## CITY of NOVI CITY COUNCIL

**SUBJECT:** Approval of the request of Beck South, LLC for JSP13-75 with Zoning Map Amendment 18.706 to rezone property in Section 29, on the southwest corner of Beck Road and Ten Mile Road from R-1, One-Family Residential to R-3, One-Family Residential with a Planned Rezoning Overlay, and to approve the corresponding concept plan and PRO Agreement between the City and the applicant. The property totals 41.31 acres and the applicant is proposing a 64-unit single-family residential development.

## PLAN REVIEW CENTER REPORT

Rezoning request from R-1, One-Family Residential to R-3, One-Family Residential with Planned Rezoning Overlay (PRO) – Revised Concept Plan

**PLANNED REZONING OVERLAY (PRO) PLAN**

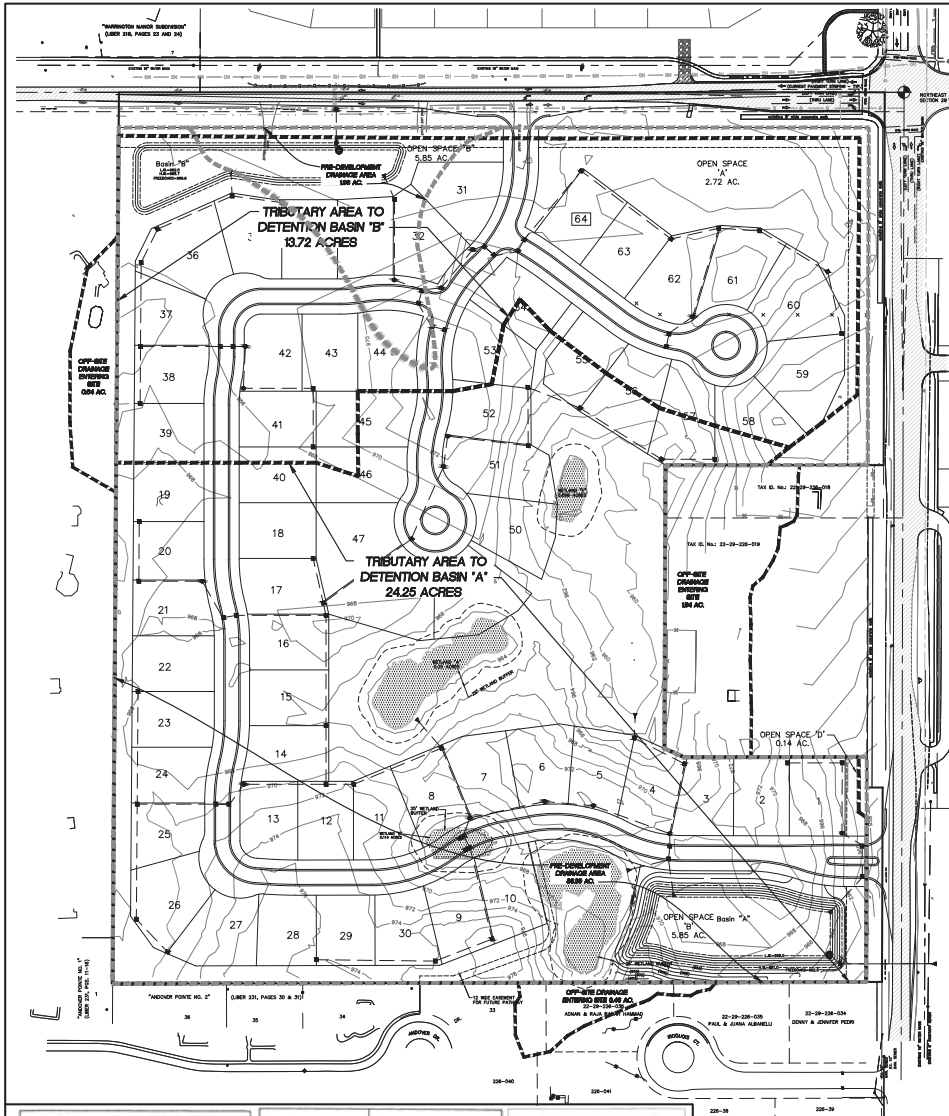
The *Planned Rezoning Overlay (PRO) Plan* (Sheet 2) indicates six (6) on-site wetland areas. These wetland areas were delineated by King & MacGregor Environmental, Inc.

The following table summarizes the existing wetlands and the proposed wetland impacts as listed on the *Planned Rezoning Overlay (PRO) Plan* (Sheet 2):

**L-1**

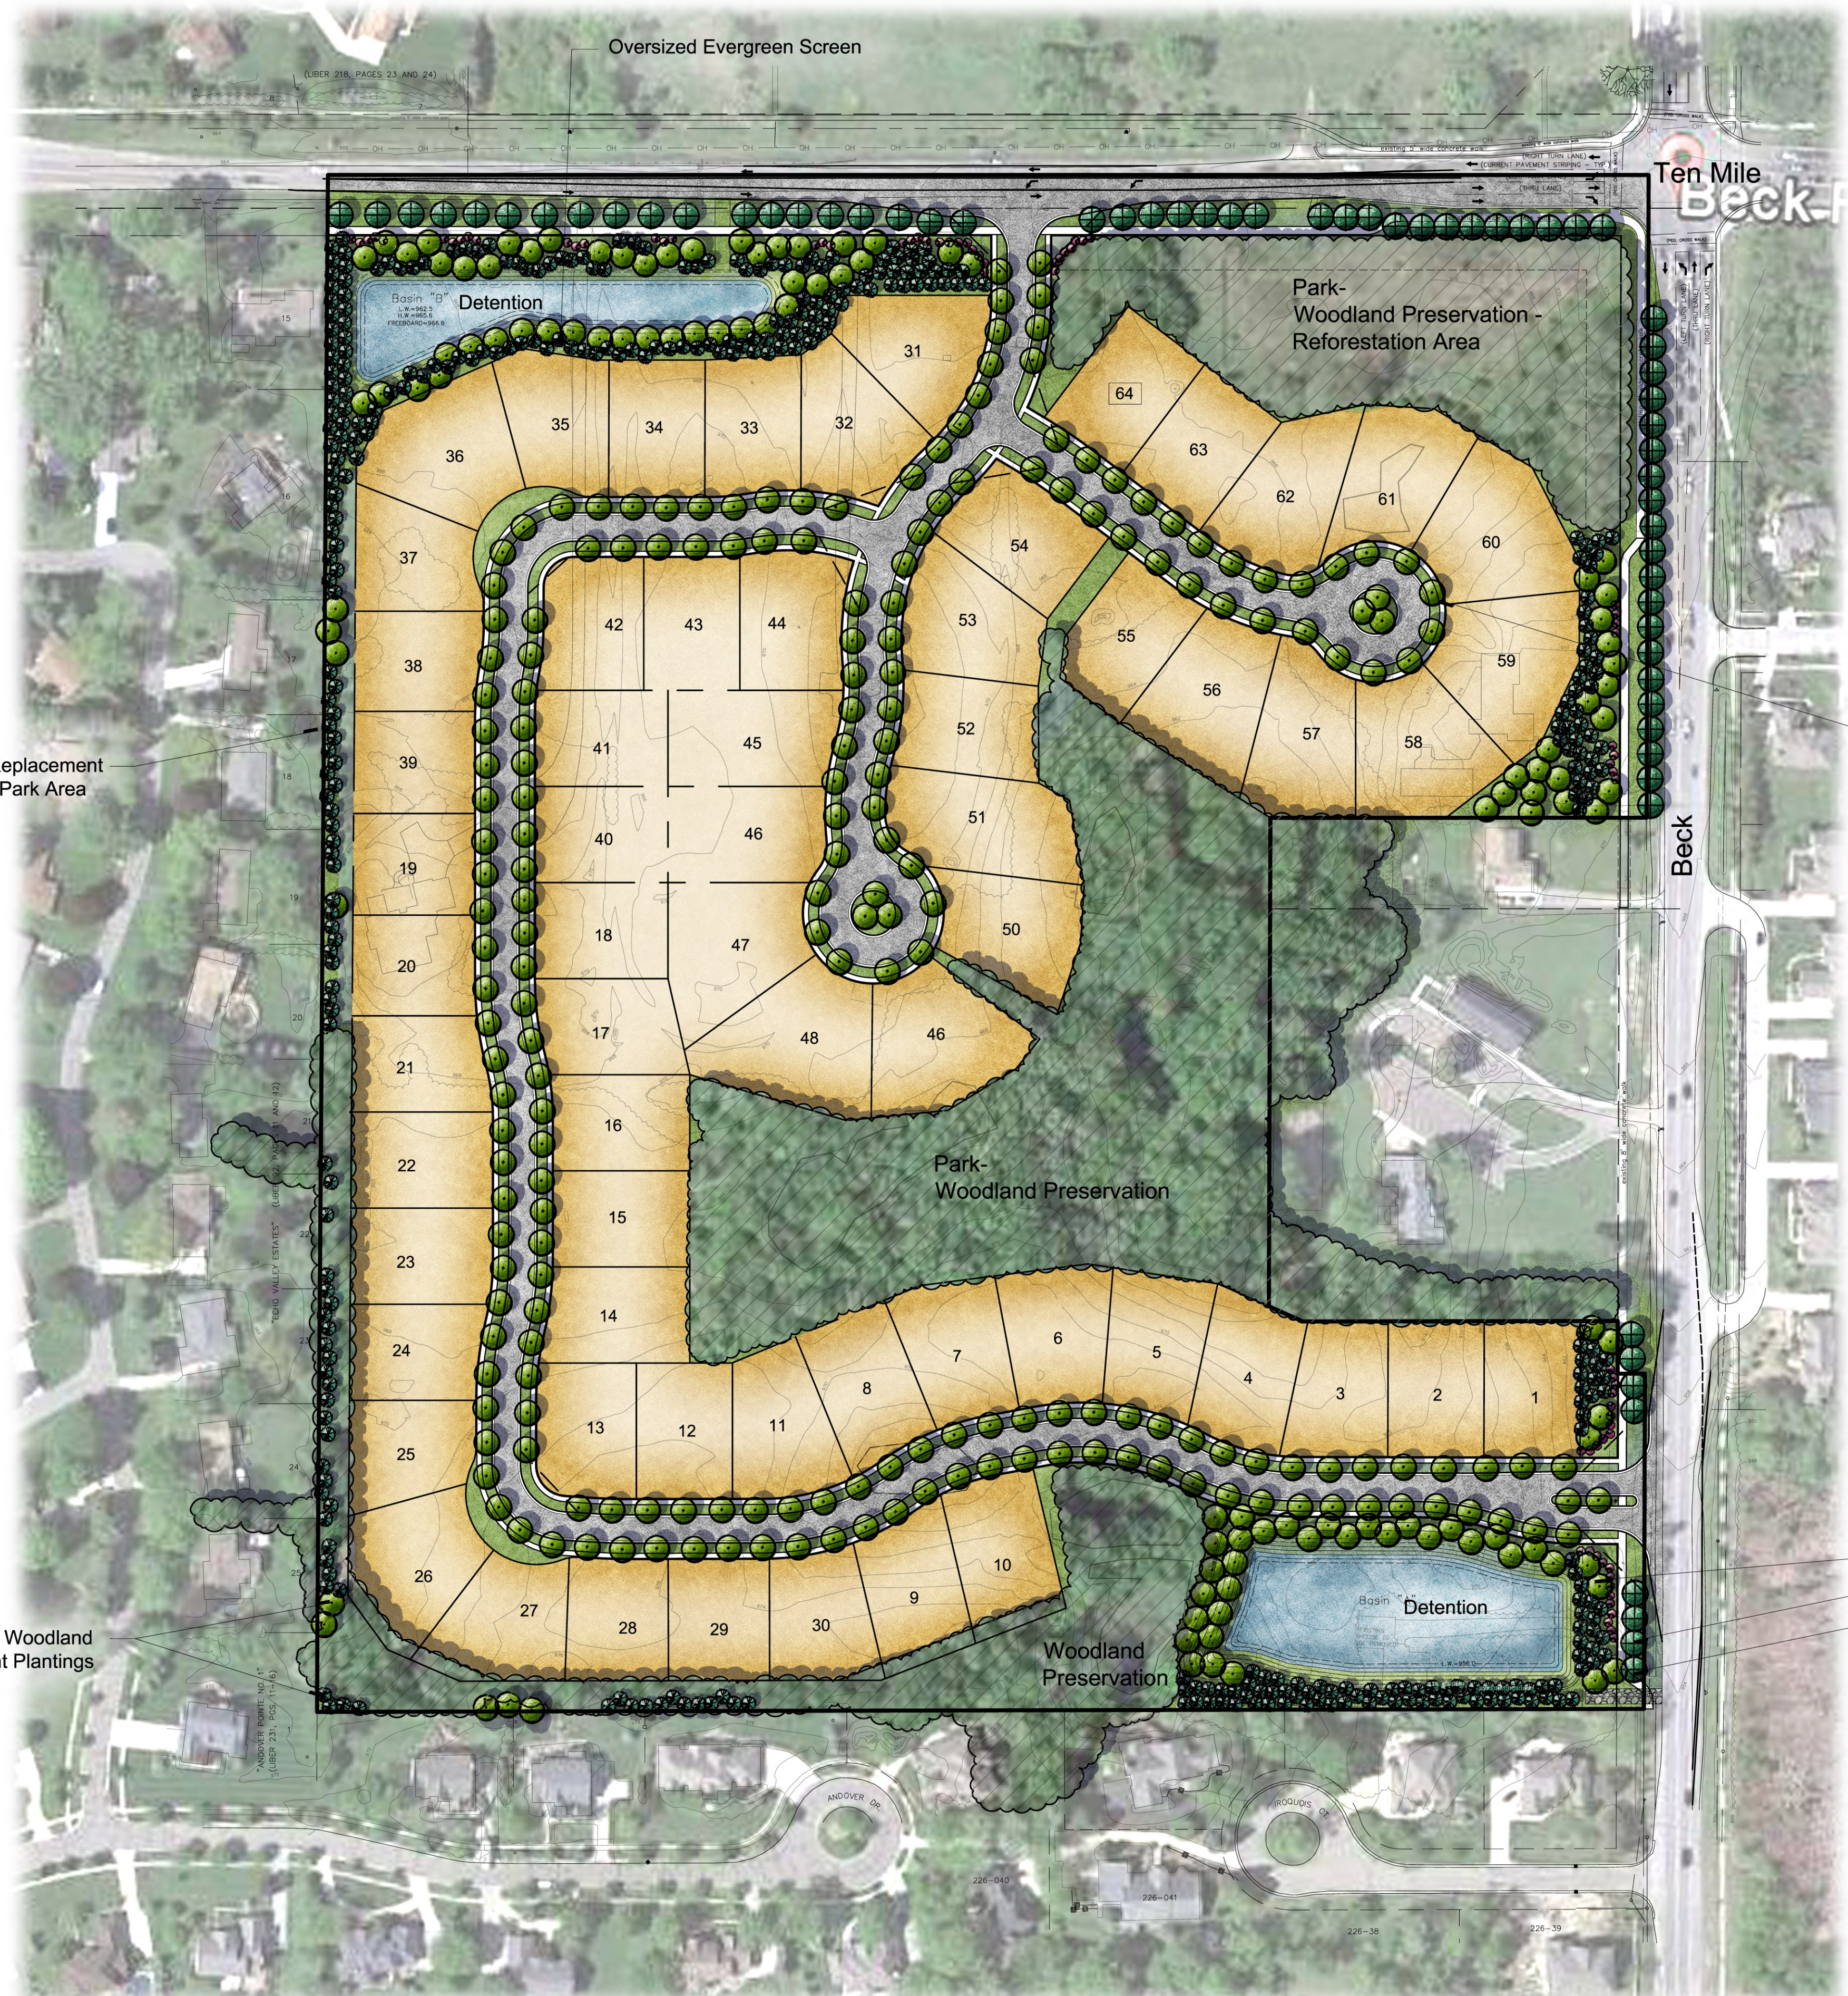
In addition, the *Landscape Plan* (Sheet L-1) notes that 796 Woodland Replacement Tree credits will be provided on-site and 1,101 tree credits will be paid into the City of Novi Tree Fund. The number of Woodland Replacement Trees to be provided on-site has increased by 176 Woodland Replacement Credits from the previous plan.

Title:  
**Woodland Plan**

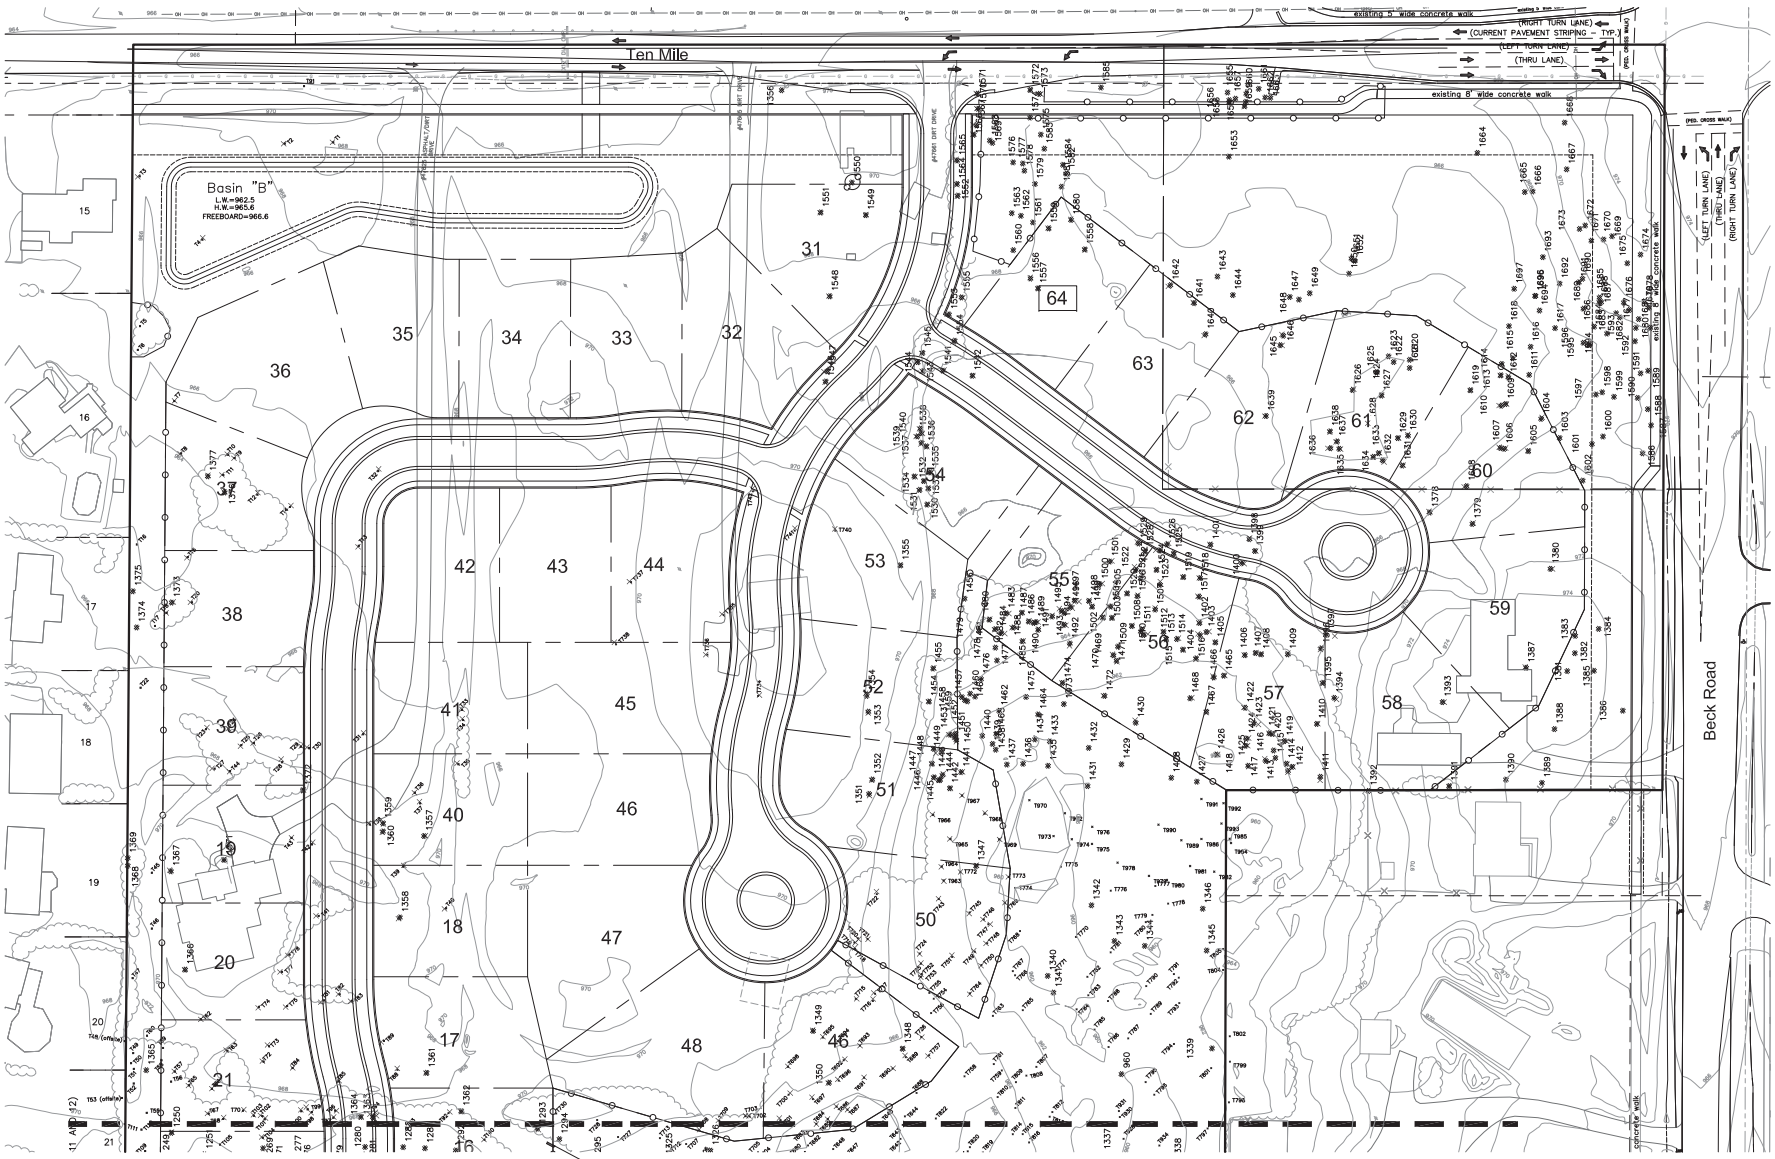
A *Woodland Summary* Table has been included on the *Woodland Plan* (Sheet L-4). The Applicant has noted the following:

The current Woodland Summary on Sheet L-4 appears to contain several mathematical errors. In addition, the Total Replacements Required is listed at 1,897 trees. The applicant should review these calculations and revise the Plan as necessary.
